Site, Surrounding Zoning
5733 Vine St.

URBAN DESIGN PANEL MINUTES

2. **Address:** 5733 Vine Street
DA: 406329
Use: Mixed (4 storeys)
Zoning: C-2
Application Status: Complete
Architect: Rositch Hemphill & Assoc.
Owner: H.Y. Louie Co. Ltd.
Review: First
Delegation: Keith Hemphill, Bruce Hemstock
Staff: Eric Fiss

PROJECT TITLE:
**EAST & NORTH
ELEVATIONS**

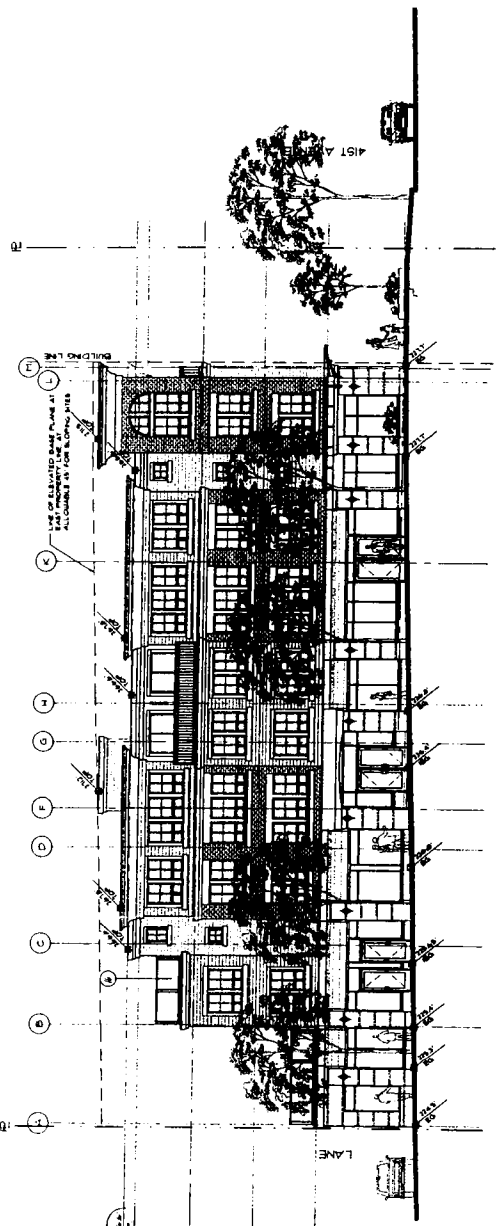
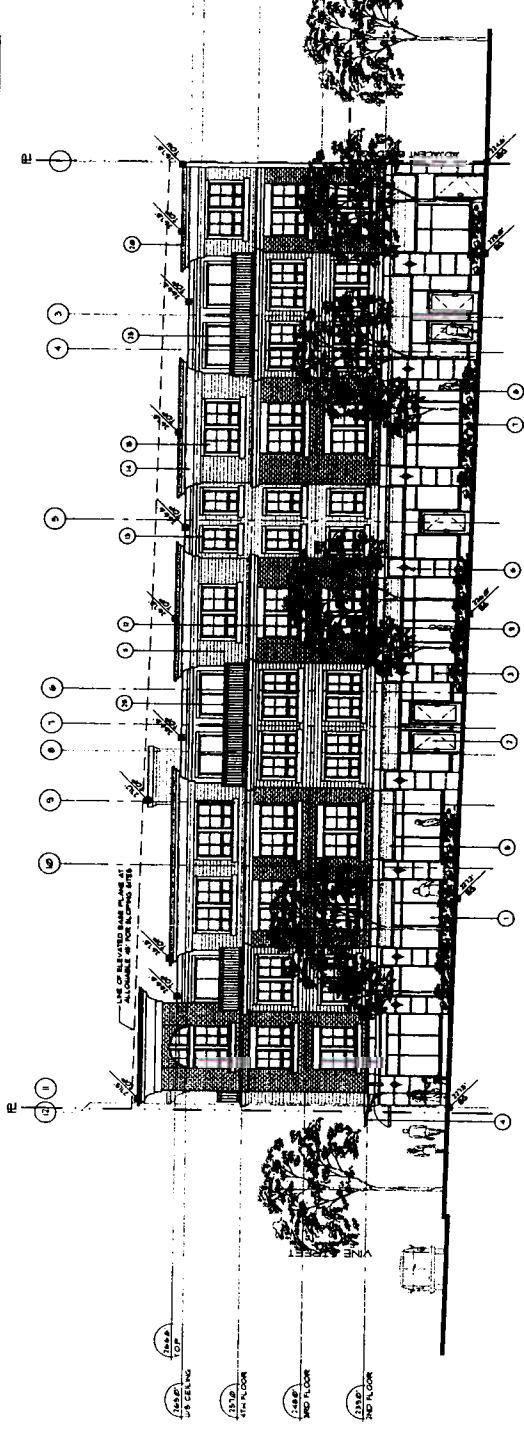
Some Panel members questioned the number of different colours and materials being used, suggesting simpler would be better.

COURTYARD
SECTIONS/ELEVATIONS

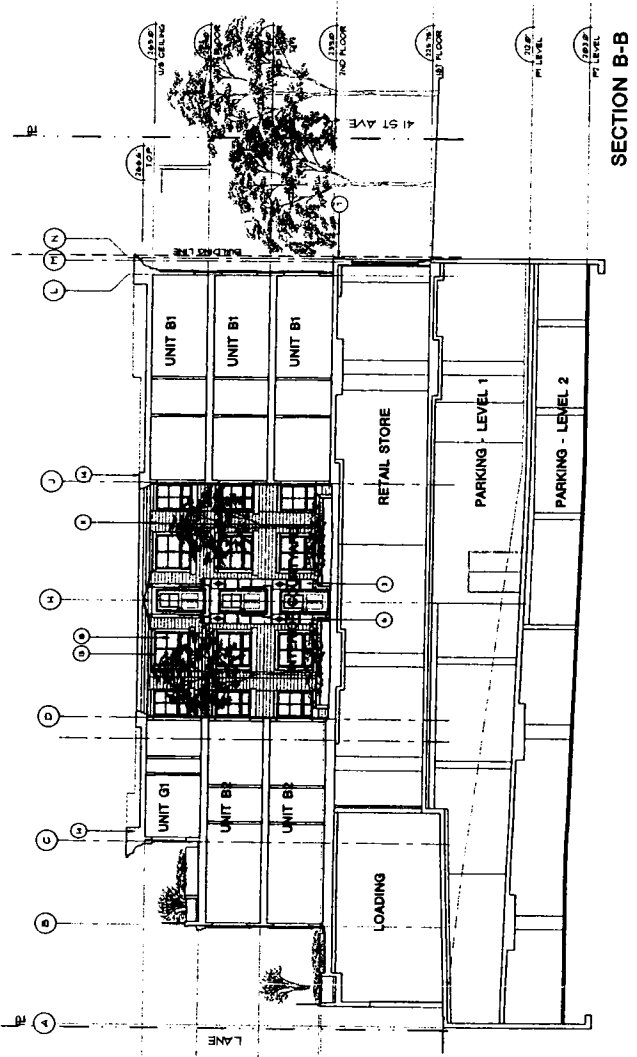
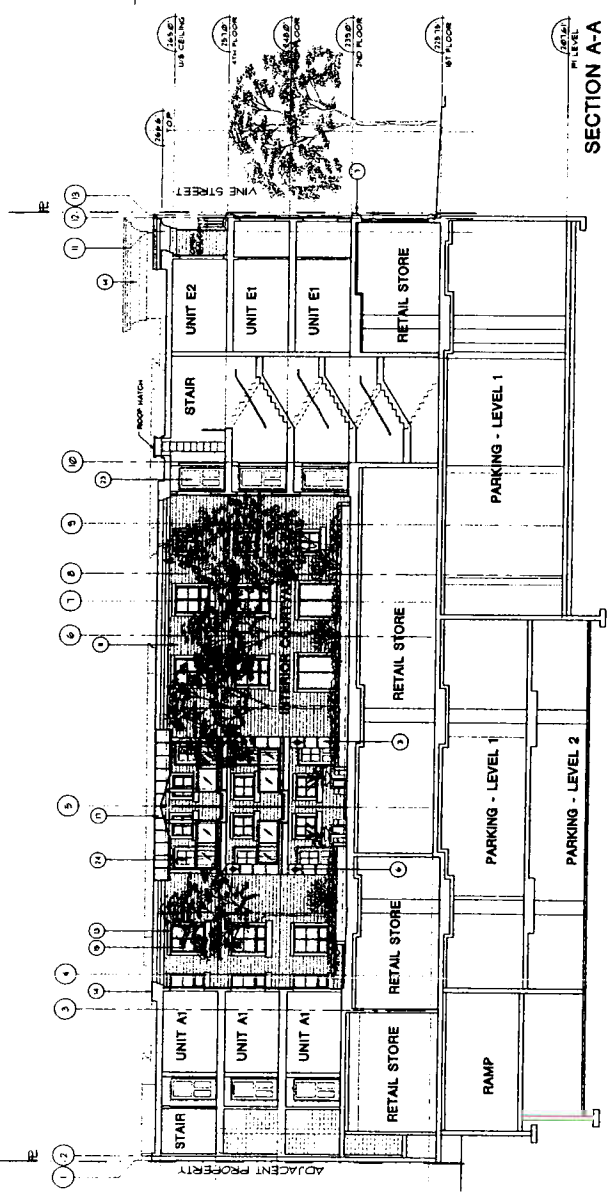
The Panel had no concerns about livability and was confident the courtyard will work quite well. One Panel member recommended treating the bedroom windows facing into the courtyard so that they are partially screened or blocked. There were some concerns about the "floating bridges" rather than a more typical galleria courtyard because they will never be gathering spaces where residents can look down onto the courtyard below. They also have a negative impact on the courtyard in terms of shadowing. On the plus side, this arrangement does avoid the interior corridor and provides for more livable floor plans and allows for cross ventilation in the units. One Panel member suggested looking at having two lobbies which would reduce the amount of corridor space crossing the courtyard. One Panel member questioned whether the trees in the courtyard would actually achieve the size being portrayed. There was a recommendation to consider mosaic paving in the courtyard.

Applicant's Response: Mr. Hemphill assured the Panel the courtyard will be very well lit, as is the experience with a similar courtyard project. He added, locating the walkways in the centre is very deliberate, to avoid people walking directly beside bedrooms. As well, particularly at the upper levels, it provides a transparent but obvious separator. The light from the courtyard also makes a significant difference to the light within the interior of the units. He stressed, the intent was not to achieve a highly livable courtyard, rather an alternative to a double loaded corridor arrangement.
